Access Compliance Report

Public Rights-of-Way

(Pedestrian Signals)

Intersection ID: N/A	Main Street:	Cross Street: N/A	Location: N/A
ADA ID: EEC604076FEE	Signal Type: One Push Button-Non APS	Overall Compliance: No	Severity Score: BTN 1: N/A BTN 2: N/A No BTN: N/A
Codes/Mitigation Info/Possible Solution		Field Measurements/Component Compliance

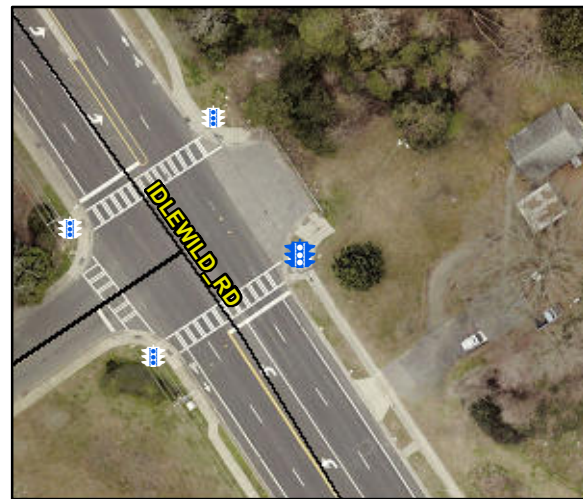
PROW/ADA: TMUTCD 4e.08, R404.2, R404.3, R406.2

Possible Solutions: Replace Signal Push Button With APS Button on New Post. Remove & Relocate Sign.
